Appendix E – 2024 Community Involvement in Design Phase

Draft Supplemental Environmental Assessment
Morgan Shoal Revetment Reconstruction (45th - 51st)

MORGAN SHOAL COMMUNITY UPDATE

PROJECT 22703: CHICAGO SHORELINE PROTECTION PROJECT
45TH STREET TO 51ST STREET (MORGAN SHOAL)
REVETMENT RECONSTRUCTION

Pebble Beach Dynamic Revetment

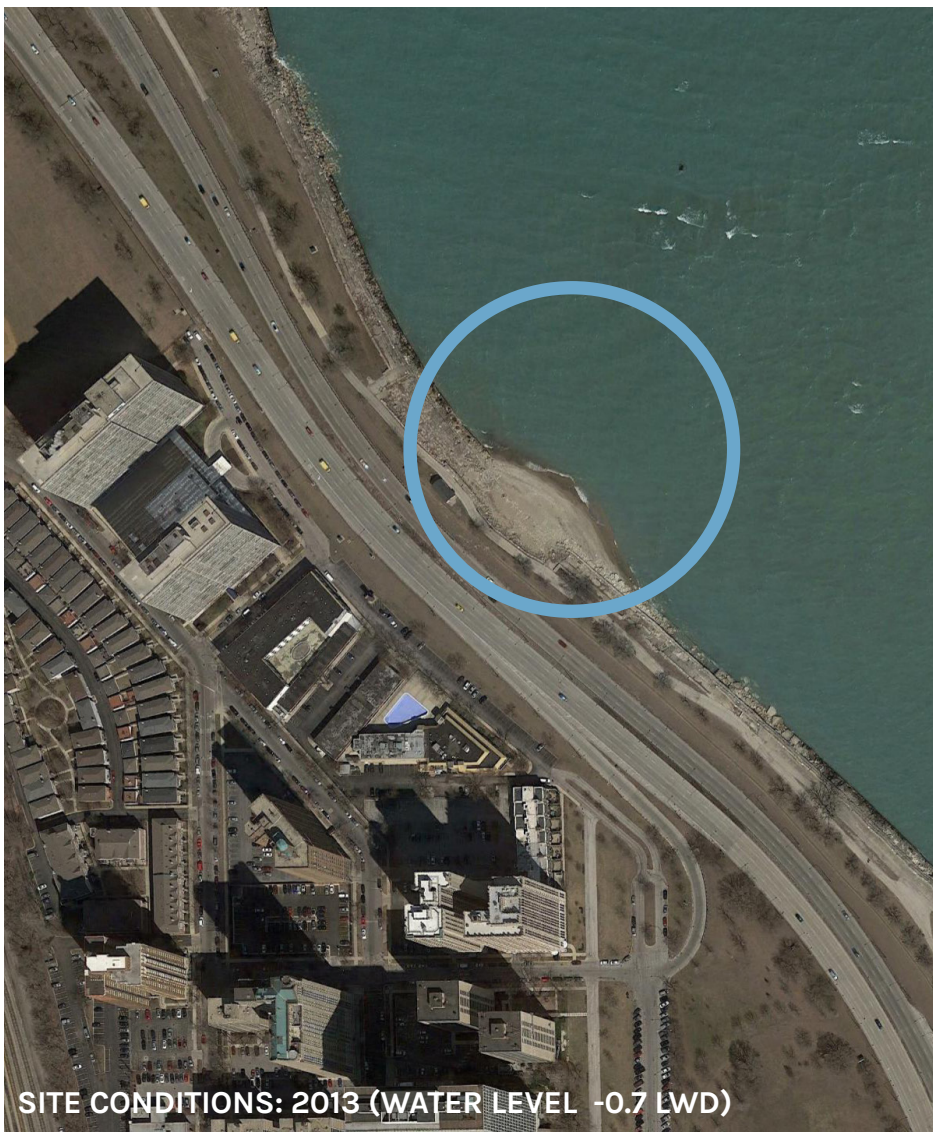
"Other examples of dynamic revetments? More details of what dynamic revetments are constructed of?"

- A dynamic revetment differs from a typical revetment primarily:
 - has a shallower slope
 - uses much smaller material
 - undergoes some re-shaping resulting from waves
- The dynamic revetment replicates a natural cobble beach
- All available existing pebbles will be salvaged and added to the new 1- to 5- inch cobbles. The new structure will be much bigger than the existing pebble area

Pebble Reuse

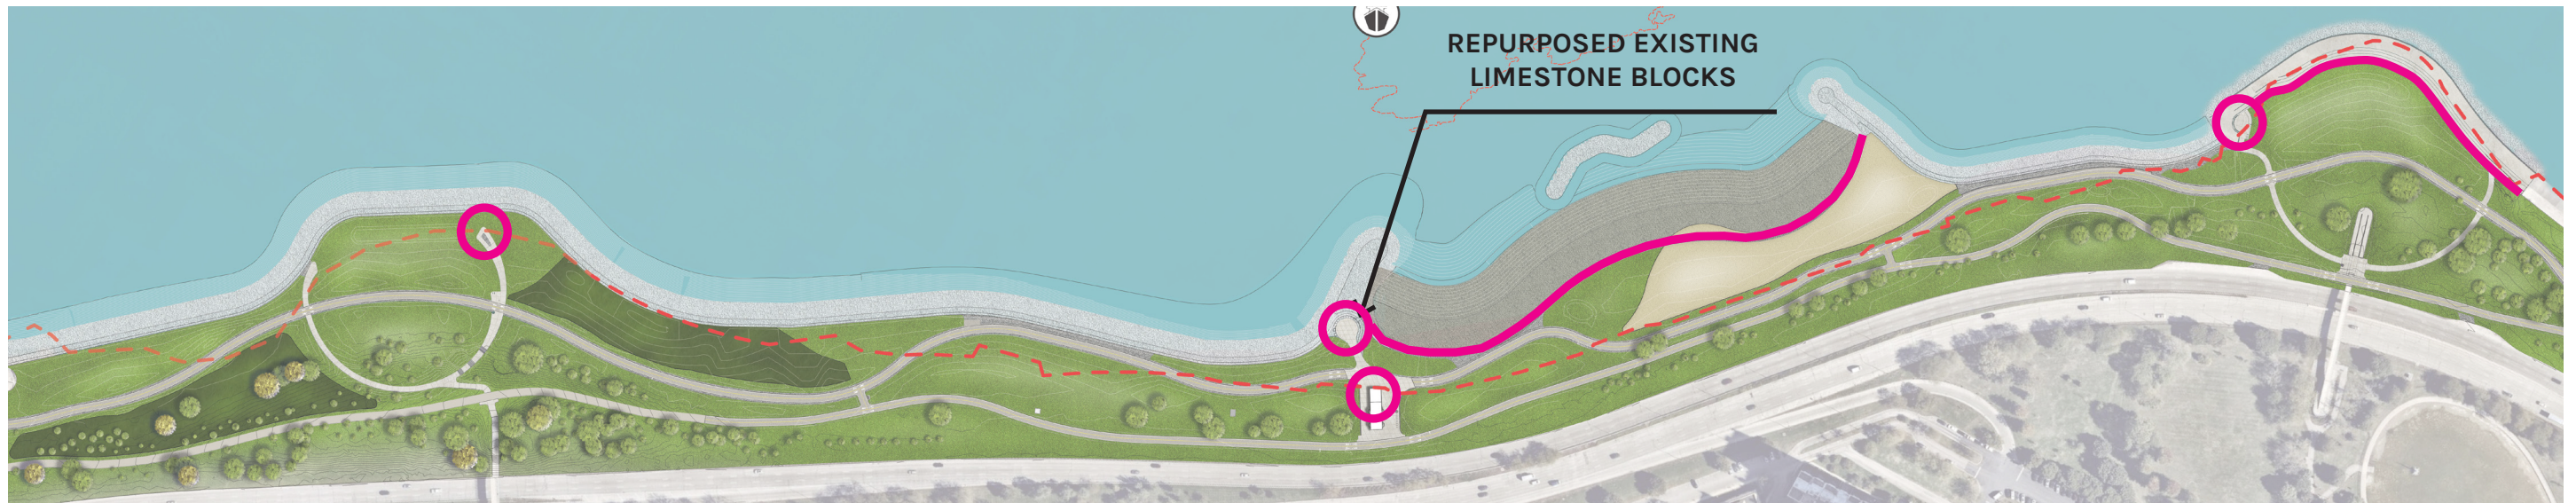
"Why not keep/re-use/be creative with the pebbles/rocks from 49th - 50th instead of importing a dynamic revetment?"
